Support Document for the Revised National Priorities List Final Rule – Jervis B. Webb Co.

**Support Document for the
Revised National Priorities List
Final Rule
Jervis B. Webb Co.
May 2012**

**Site Assessment and Remedy Decisions Branch
Office of Superfund Remediation and Technology Innovation
Office of Solid Waste and Emergency Response
U.S. Environmental Protection Agency
Washington, DC 20460**

Figure 3 – Excerpt from HRS Documentation Record Reference 10 Figure 11

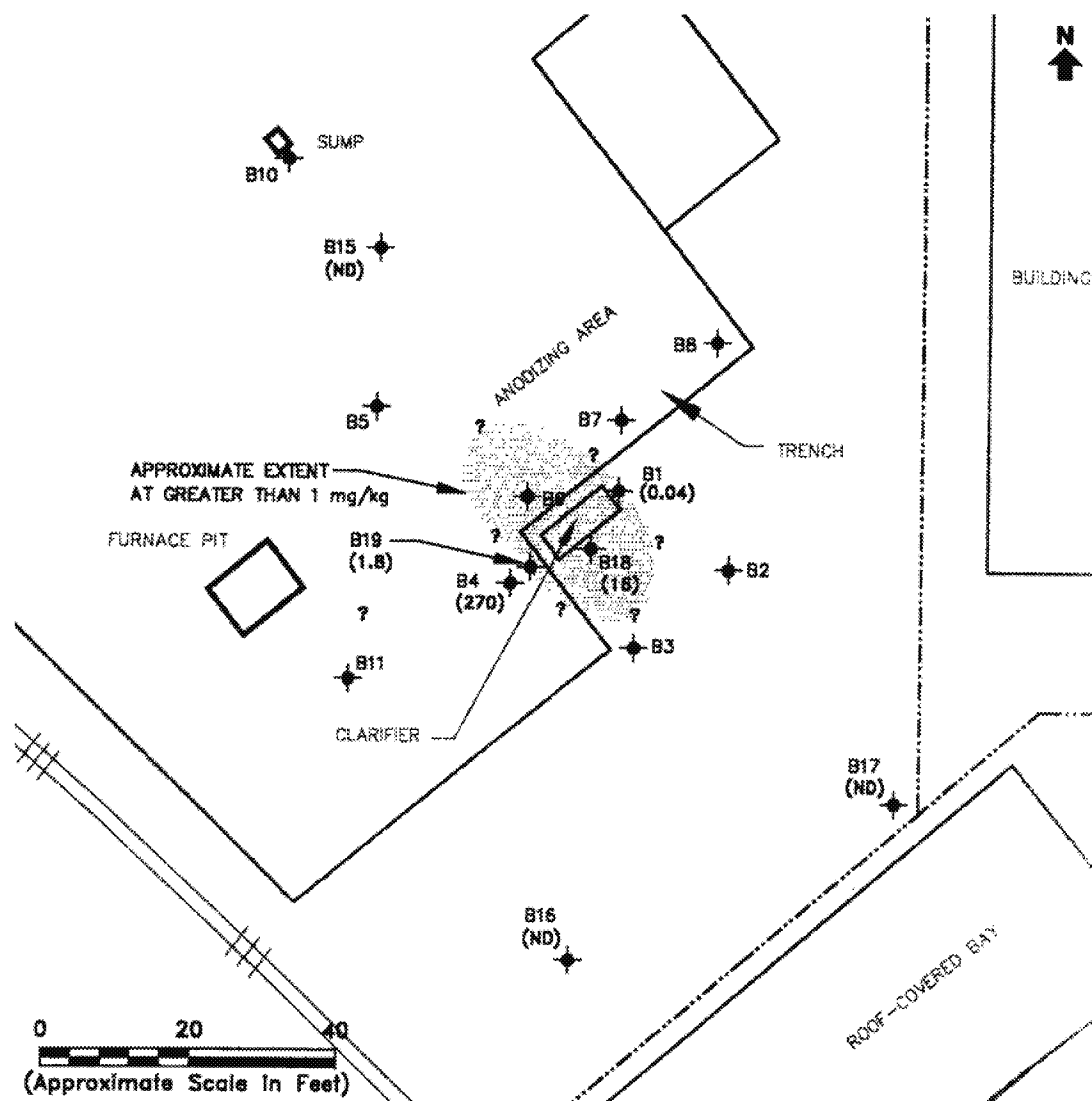
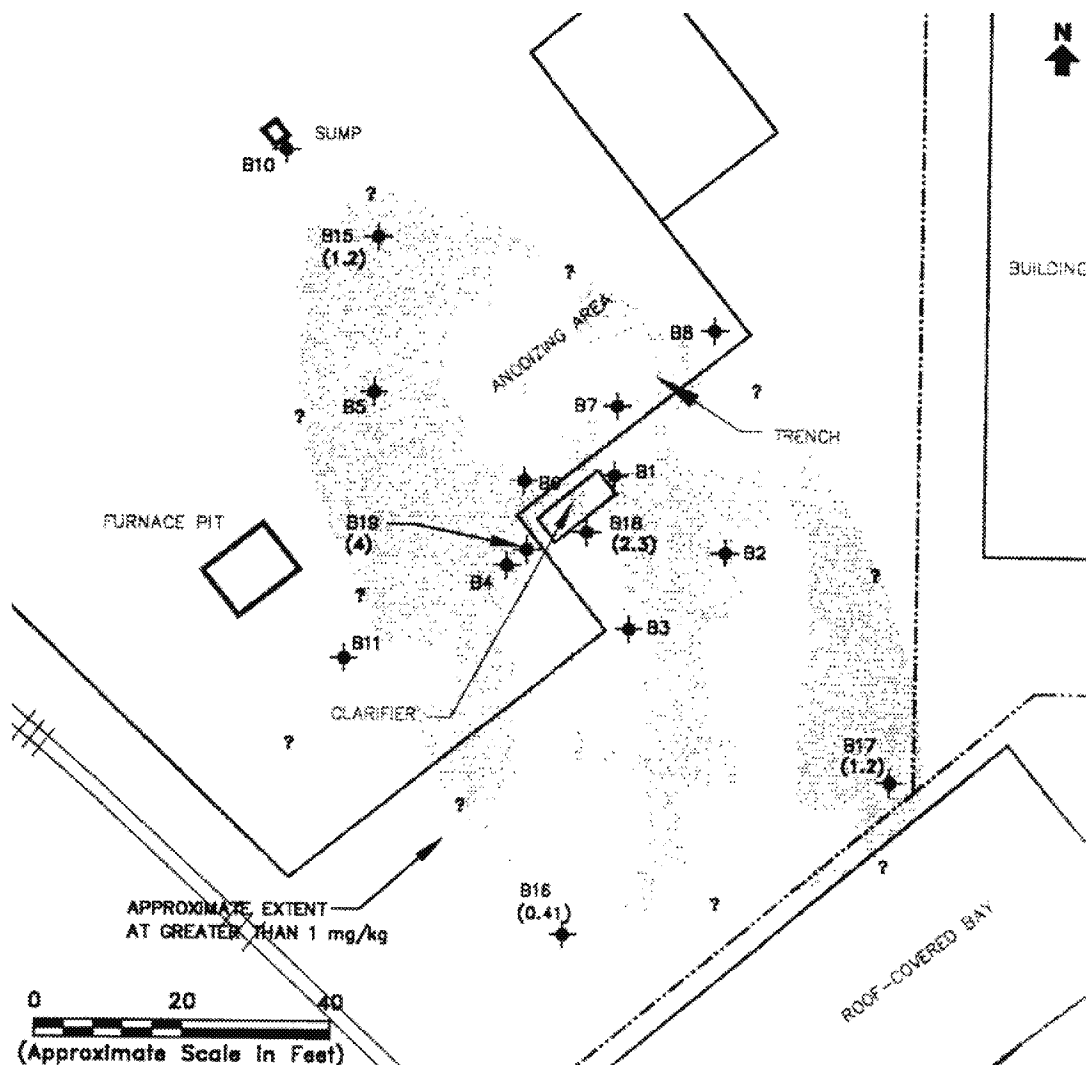
The presence of a continuous clay layer at 25 feet beneath the site is inferred by Dragun based on 4 soil borings from the December 1997 sampling event (B15, B17, B18 and B19). The 2001 Dragun Report Figure 4 referred to by the commenter is derived from 1998 EKI soil boring information detailed in Reference 10 of the HRS documentation record at proposal. However, for one of these borings, B19, the soil boring log **does not show any clay layer**. Additionally, boring B18 shows the clay layer thinning to approximately 1.5 ft thick in the same area as B19 (see pages 84-91 of Reference 10 of the HRS documentation record at proposal).

And, as can be seen in Figures 11 and 12 on pages 44-45 of Reference 10 of the HRS documentation record at proposal (see also Figures 3 and 4 of this support document below), the higher TCE concentrations (those concentrations greater than 1 mg/kg) of shallow soil contamination at about 20 ft bgs approximated by a shaded oval in Figure 11 are centered near the former facility wastewater clarifier (this clarifier was described as a possible source not scored on page 22 of the HRS documentation record at proposal). Higher levels of deep soil contamination at 40 ft bgs shown on Figure 12 are spread over a larger approximated oval area but are still nearly centered under the 20 ft bgs oval in Figure 11. This pattern of contamination suggests that the shallow and deep soil contamination is continuous with depth and shows no break associated with a clay layer. The pattern is consistent with a scenario in which a spill at the soil surface has spread laterally as it migrated downward to

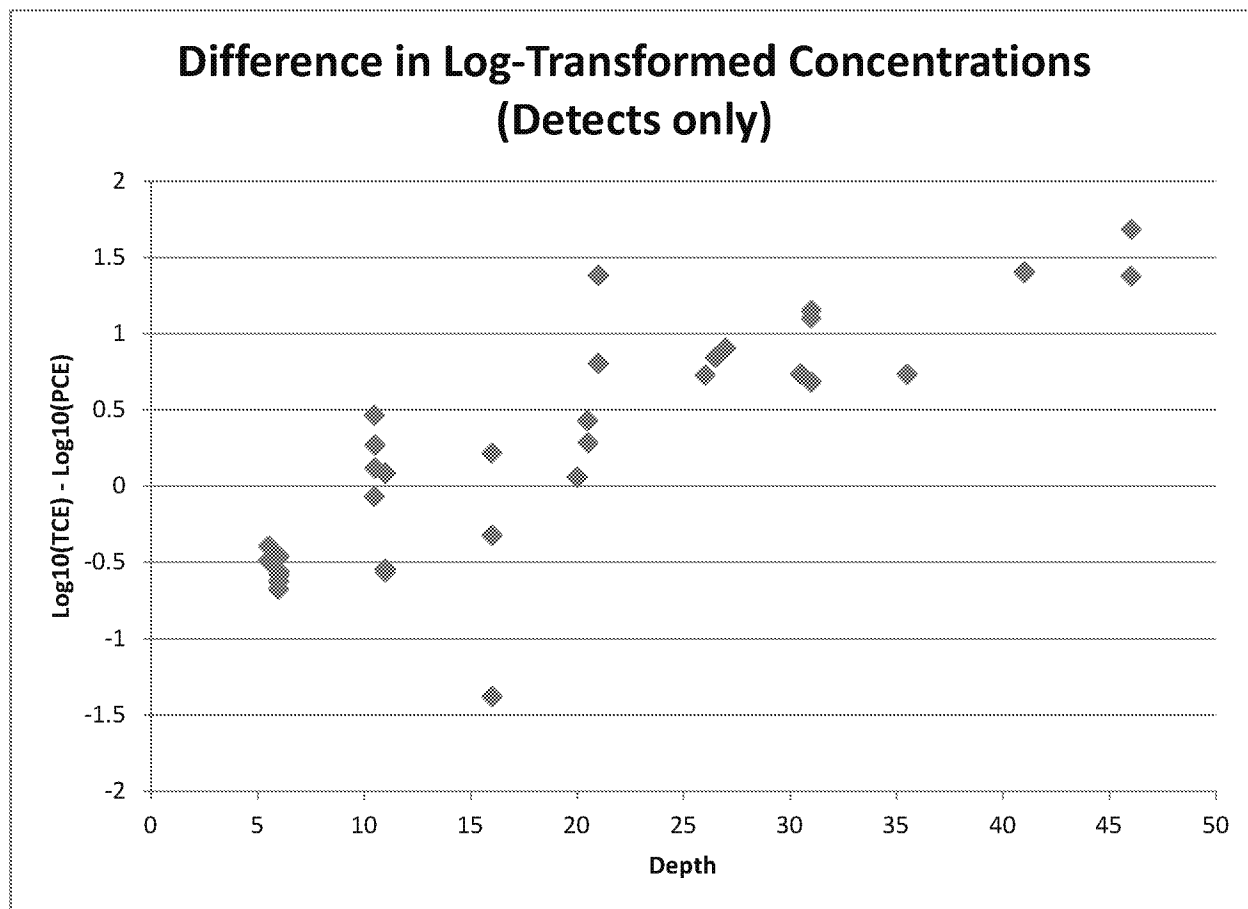
Further, when comparing the TCE and PCE distribution in Site soils against depth, there is no clear indication that the contamination below the clay layer is from a different source than that above the clay layer. If the difference

between the log of the TCE concentration and the log of the PCE concentration¹⁶ is plotted versus soil depth for available soil samples in which both TCE and PCE were detected (see Figure 1 below), the result is a gradual pattern of TCE concentrations increasing relative to PCE concentrations with increasing depth—there is no clear shift in data just around the clay layer at approximately 25-30 ft bgs, as would be expected if indeed the surficial soil and deep soil contamination were associated with separate plumes as asserted by the commenter.
